Department of Health

July 16, 1996

GMP #84

I have reviewed the plans for the 1,000, 1,250, and 1,500 gallon septic tanks with the use of fiber mesh in place of the 6 by 6 inch #12 welded wire mesh. The plans appear to comply with the minimum requirements of the Sewage Handling and Disposal Regulations.

Onsite - Product Approvals - Septic Tanks

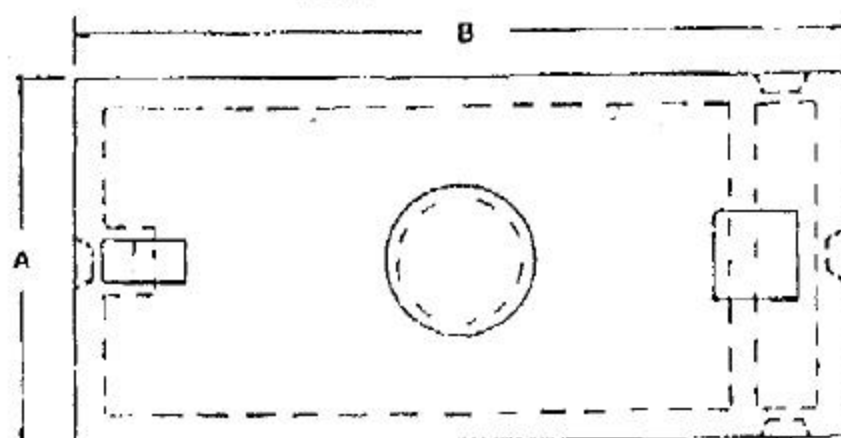
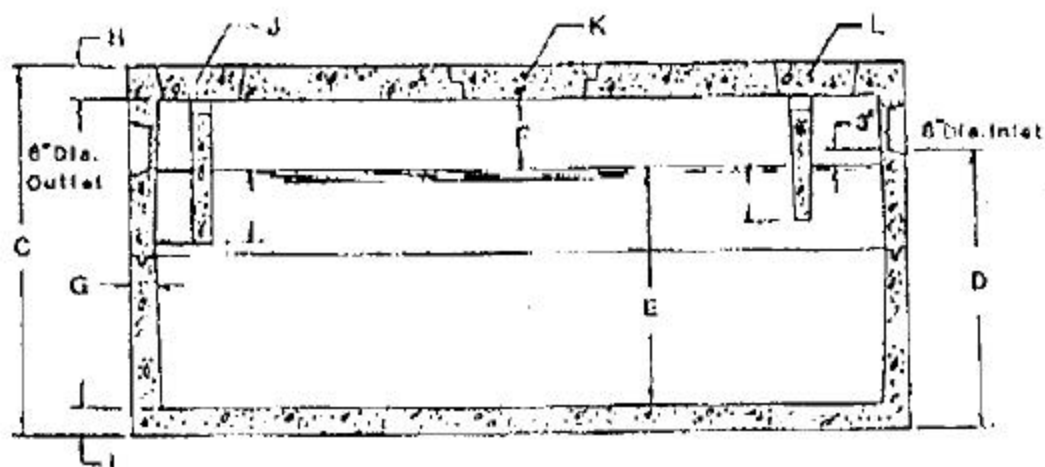
You are proposing to use either Fibermesh(R) or CAPROLAN-RC Nylon Fibers as an alternative to the welded wire mesh. The use of both of these alternative fiber mesh has been previously approved by the Department (Refer to GMP#16 and the letter from the Director dated July 8, 1986). The use of fiber mesh does not replace or substitute for the use of reinforcing rods, when the reinforcing rods are required.
